Option A / no-chair-rail comparison

OPTION A / NO RAIL - CHAIR RAIL UNDECIDED - REVIEW ONLY / DO NOT CUT

Chair rail remains UNDECIDED. Option A shows upper/lower frames without rail; the existing chair-rail design remains Option B for comparison. Original trim stays.

Proportion, retained trim and setting out

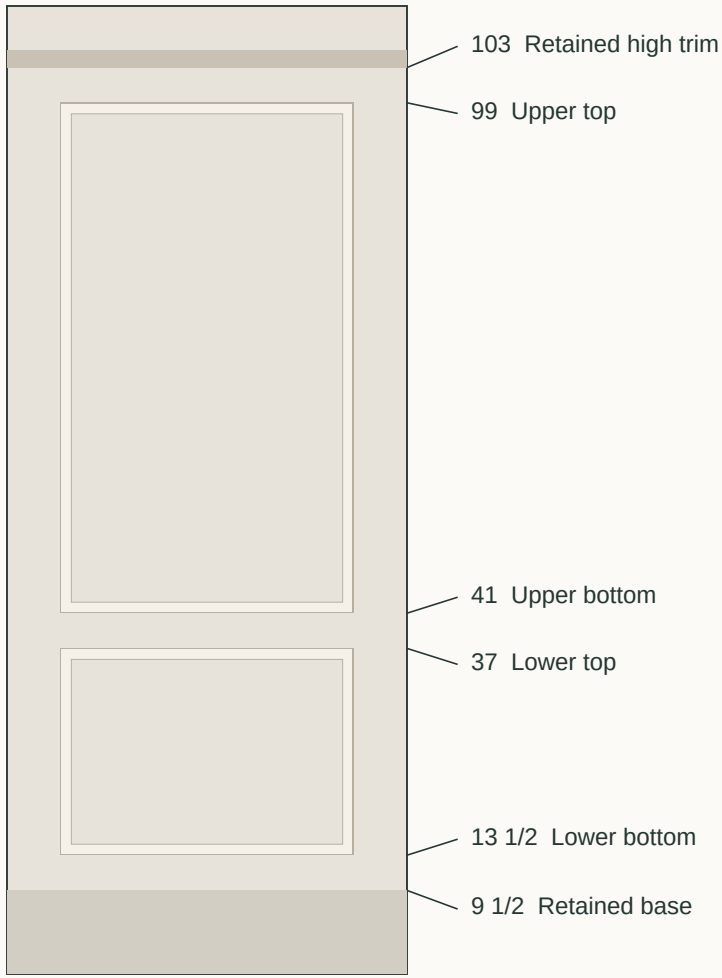
4 + 23 1/2 + 4 + 58 + 4 = 93 1/2

Clear field:103 - 9 1/2 =93 1/2 in

A closed frame, not a horizontal divider. The former rail band is absorbed into taller lower rectangles. Keep a deliberate 4-in reveal between the rows.

This nominal height stack reuses source datums. Actual base/high trim governs alignment, including its existing slope. Do not force a new laser-level line.

Outside dimensions define the frame perimeter. A 1 1/4-in face is only a drawing parameter. If selected, clear opening = outside dimension minus 2 1/2.

Bedroom A / north headboard

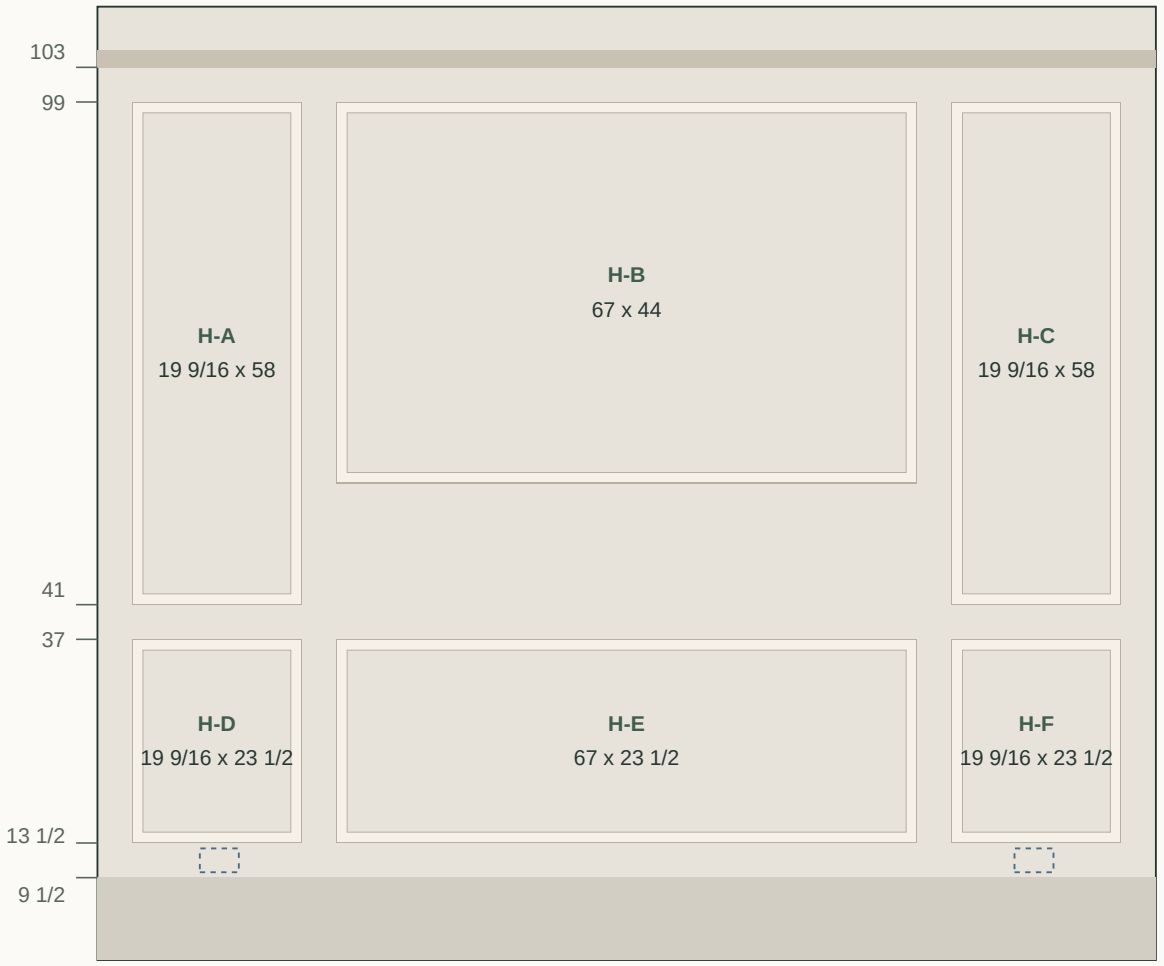
Bedroom A centre stays raised for the headboard; fireplace centre stays above the mantel. These are explicit exceptions, not missing lower/upper rows.

Lay out from each wall centreline. Show full-size tape outline before final cuts. Finished-floor datum is nominal; unknown finish build-up is not converted to subfloor marks.

Niche opening to bay corner: 122 1/8 in, recorded in R2 from Magicplan. Earlier 124-in run has unresolved endpoints.

Proposed 4-in ends and gaps: sides become 19 9/16; centre stays 67. Central upper stays 55-99 for the headboard.

Existing outlet proposal remains CL +/-47 in. Side-frame centre differs by 9/32 in; do not move an outlet to match this sketch.

Bedroom C / south shared wall

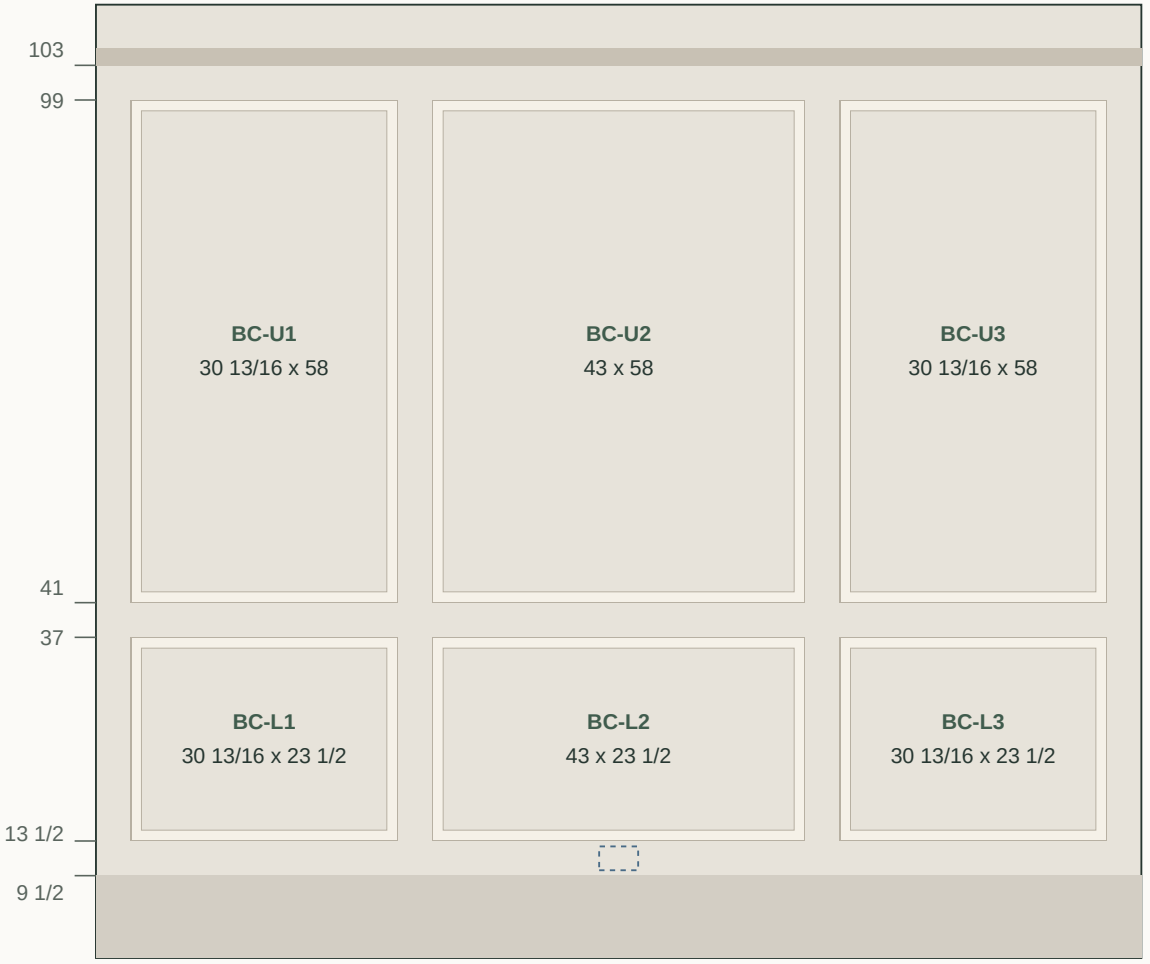
Bay corner to entry corner: 120 5/8 in, R2 plan-recorded. Earlier 121-in field report needs endpoint reconciliation.

Proposed 4-in ends and gaps: sides become 30 13/16; centre stays 43. Six frames; centreline-first layout.

This is current Wall C, formerly called Wall B. Wall B is the east bay wall and receives no applied frames.

Living L01 / three-bay wall

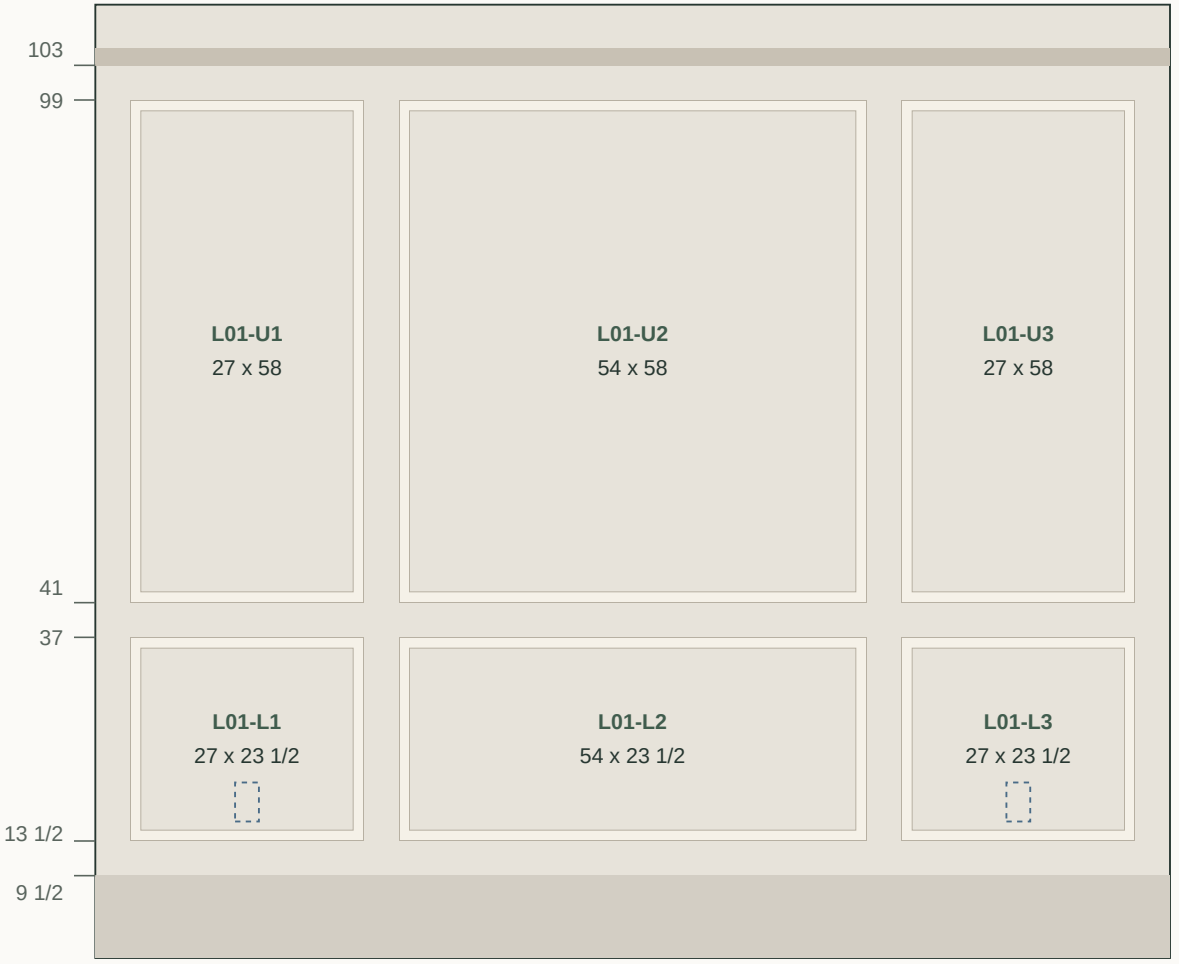
124-in run is a recovered measured-source annotation. Tisa reports field verification; the original annotated face/endpoints remain to be matched.

Retain the 27 / 54 / 27 rhythm. Lower frames grow from 17 1/2 to 23 1/2 in high.

Existing device marks are source proposals, not verified installed locations.

Living L02 / pocket-door face

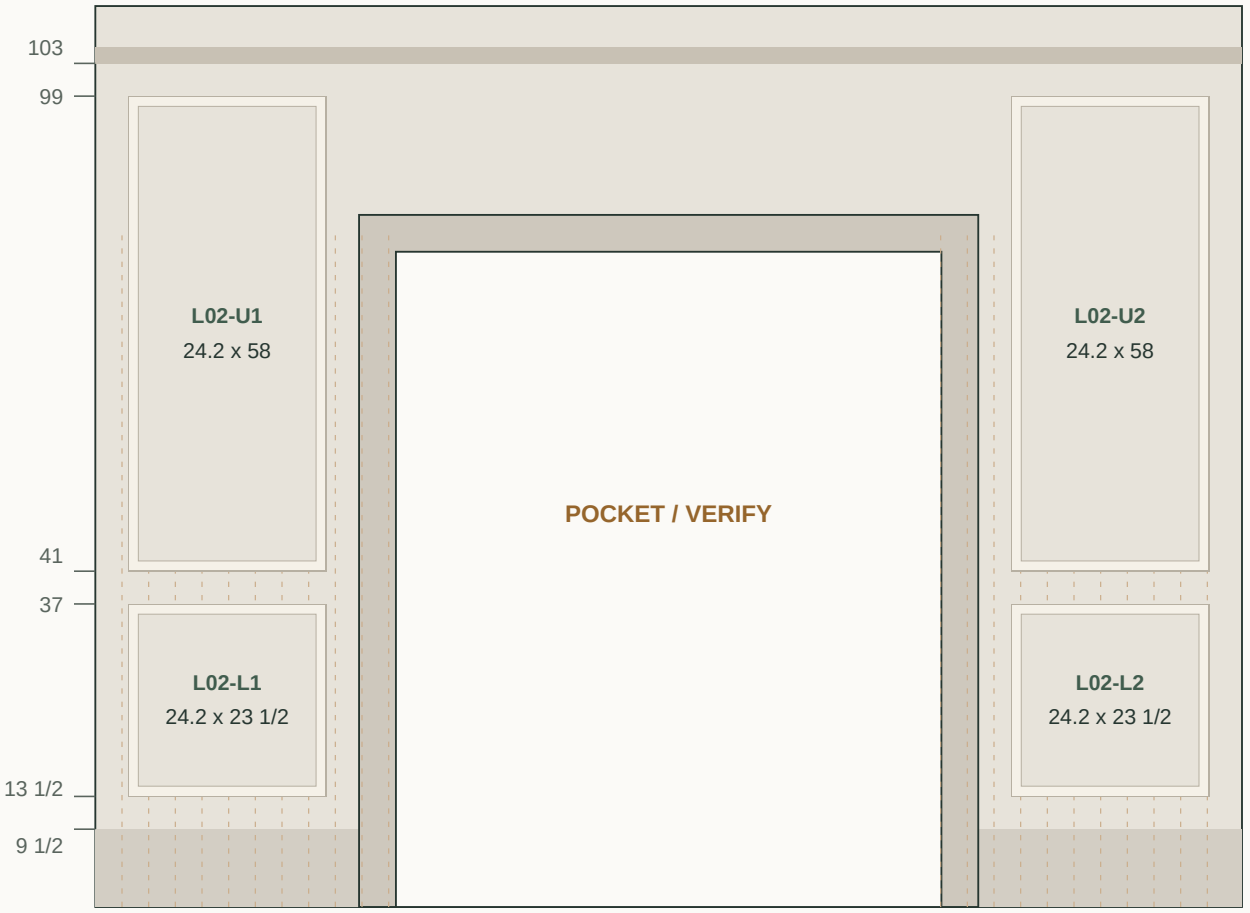
Illustration only: 140-in overall, two independent 32.2-in piers and 75.6-in cased opening. Do not use these as field cuts.

One aligned upper/lower pair per eligible pier. No rail or rail returns at casing.

Pocket cavities overlap frame areas. Actual backing and safe fixing depth are unknown; no fastener locations authorized.

Living L03 / fireplace wall

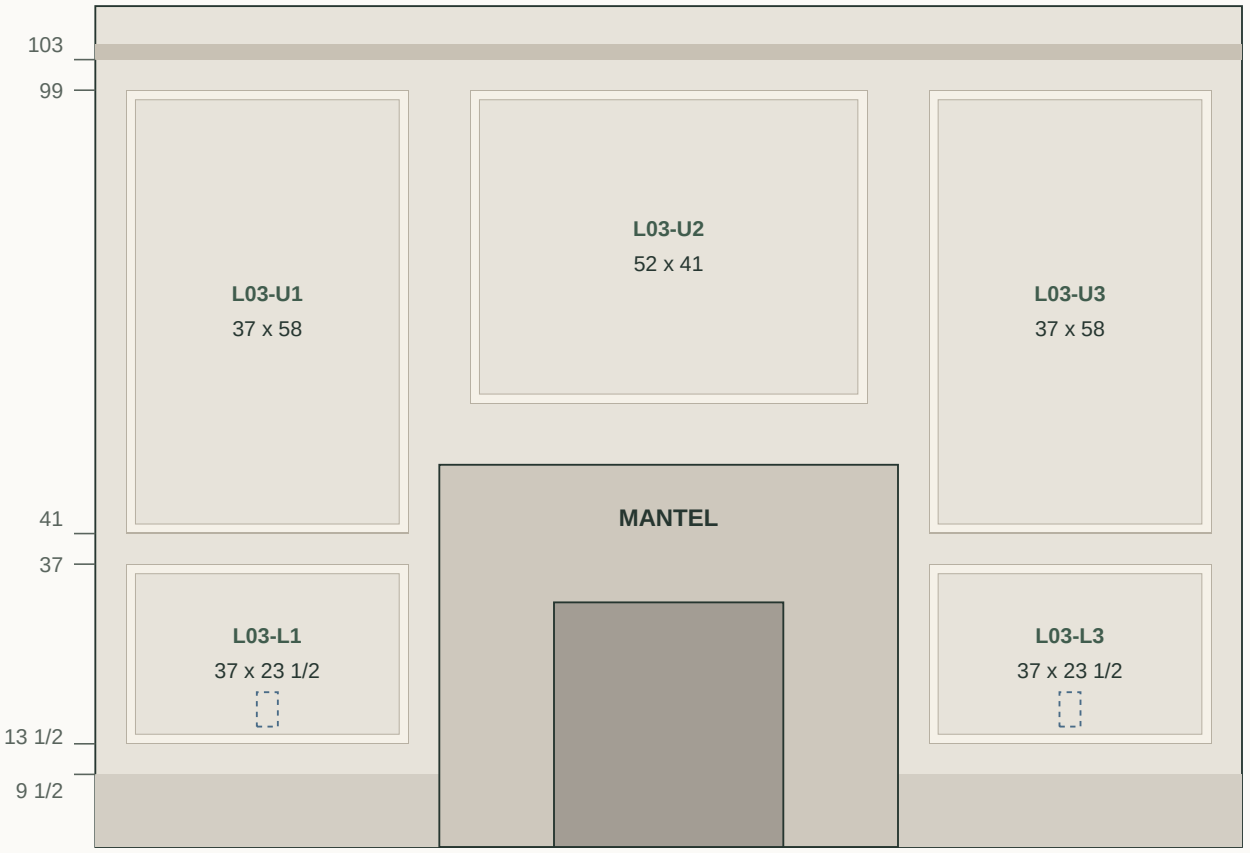
Illustration: 150-in wall, 60-in mantel zone. Measure the two side fields independently.

Side pairs retain 37-in widths; centre upper retains 52 x 41, at 58-99. No frame across fireplace opening.

Mantel size, heat/clearance requirements and device positions remain to be coordinated; this sheet does not approve combustible trim clearance.

Dining D01 / two bays

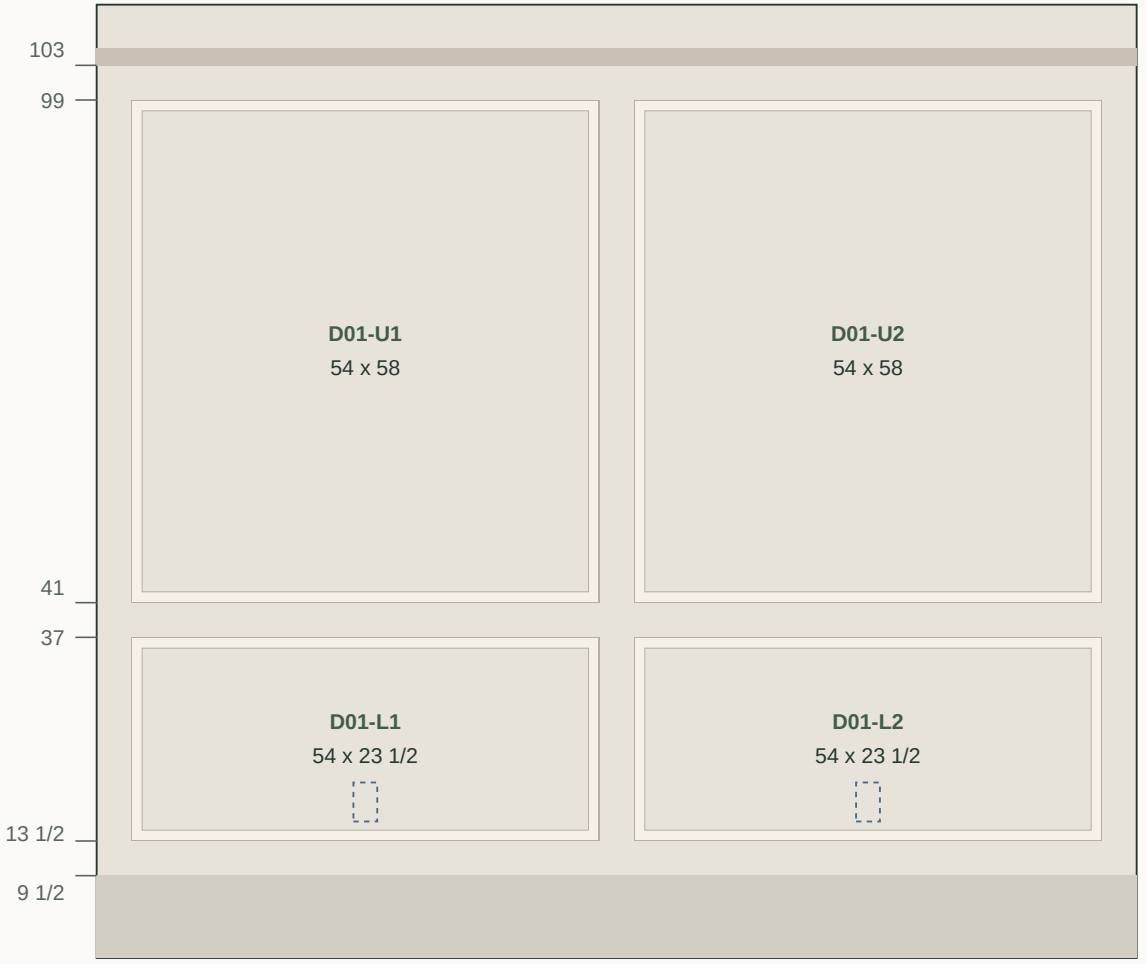
W=120 in is an illustration, not a recovered clear-run measurement. Formula per bay: (W-12)/2.

Two equal upper/lower pairs. Check actual casing-to-corner endpoints before replacing the illustrated widths.

Current outlet-height/location review remains separate. No relocation is implied.

Dining D02 / movable buffet

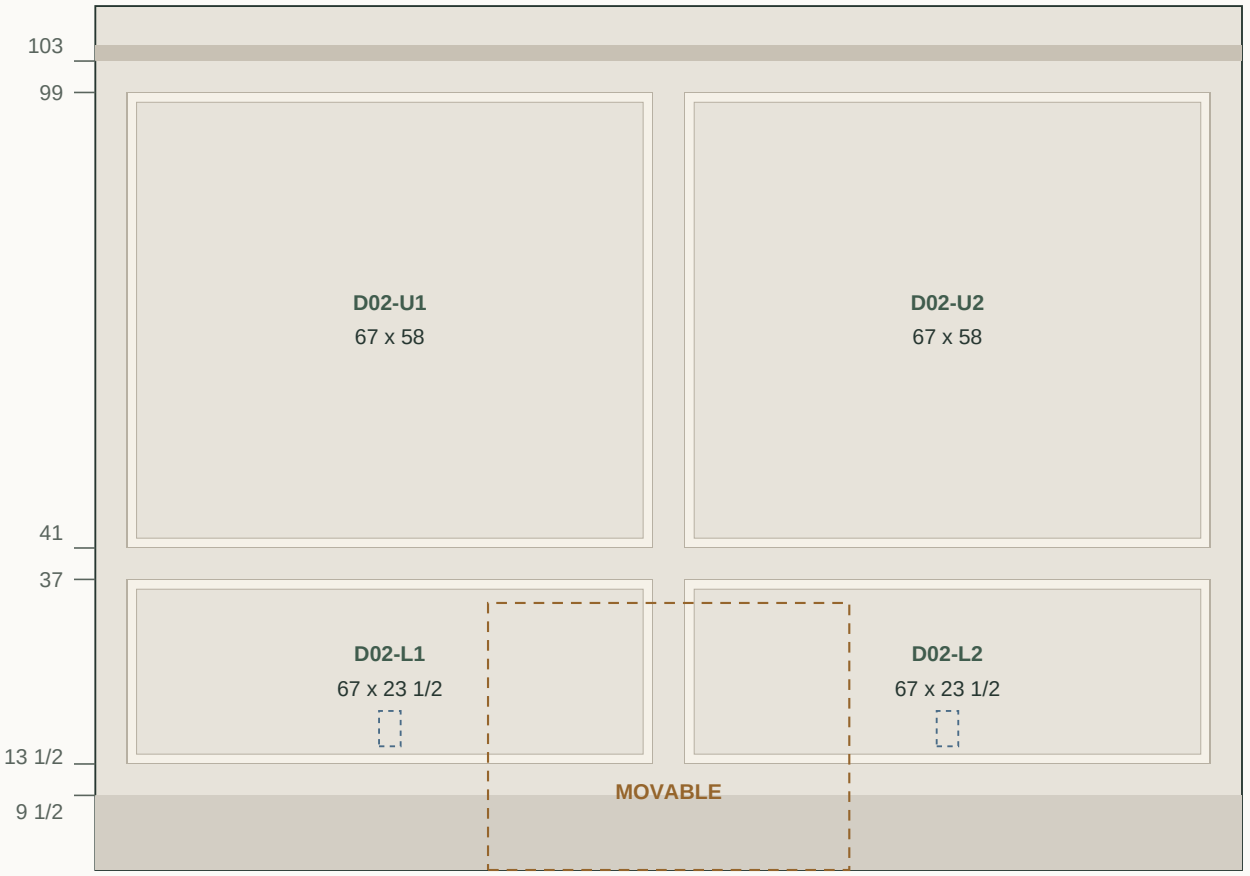
W=146 in is illustrative. Buffet is movable furniture, not a built-in boundary.

Keep two equal pairs across the wall, including behind the movable buffet. Do not revive the old five-frame scheme.

Actual clear-run width, buffet footprint and device covers need coordination.

Dining D03 / pocket-door face

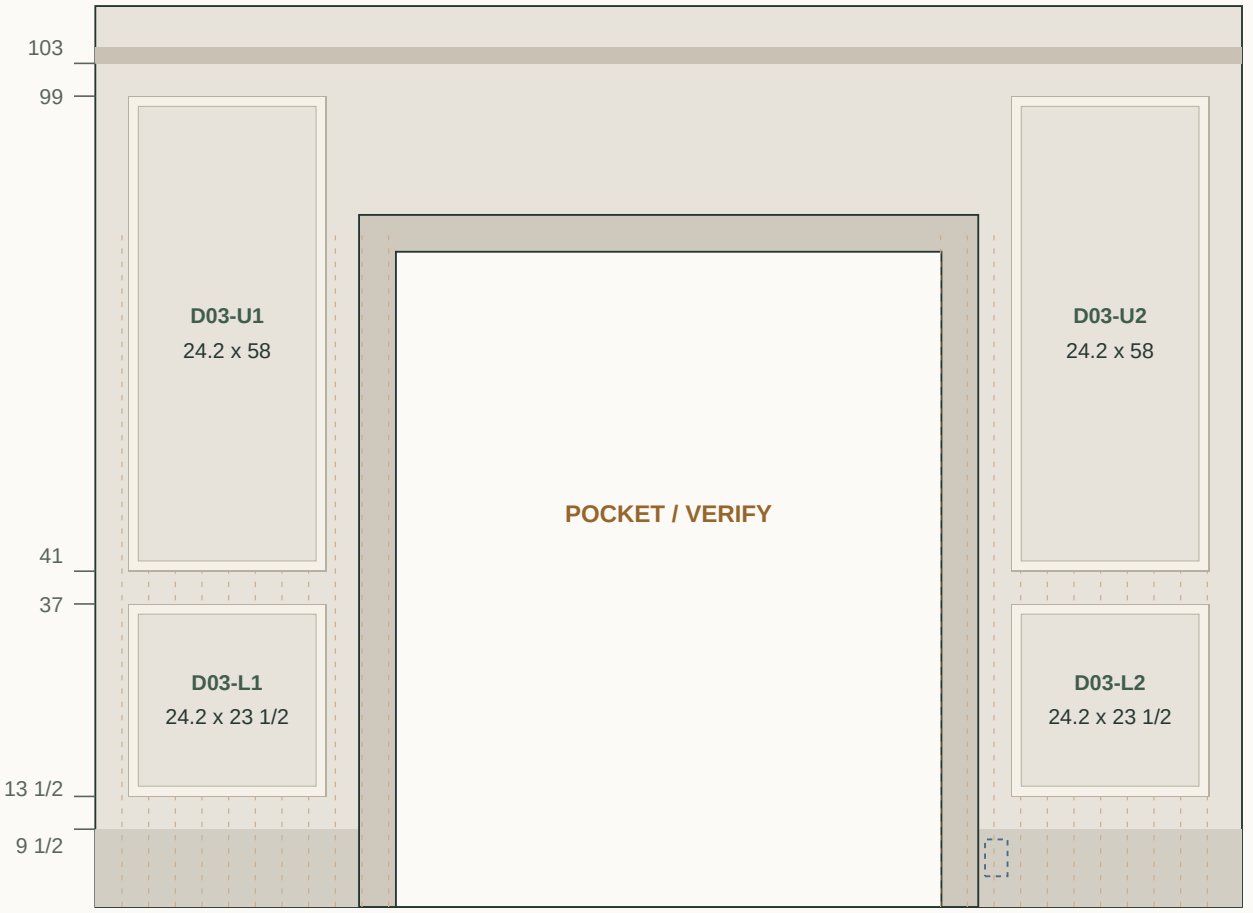
Separate face from L02: measure each pier on this side independently. The 32.2-in piers are illustrations.

Original baseboard outlet is retained as source evidence, not a verified field envelope. No new D6 in a pocket cavity.

No fixings into unknown pocket travel or door hardware.
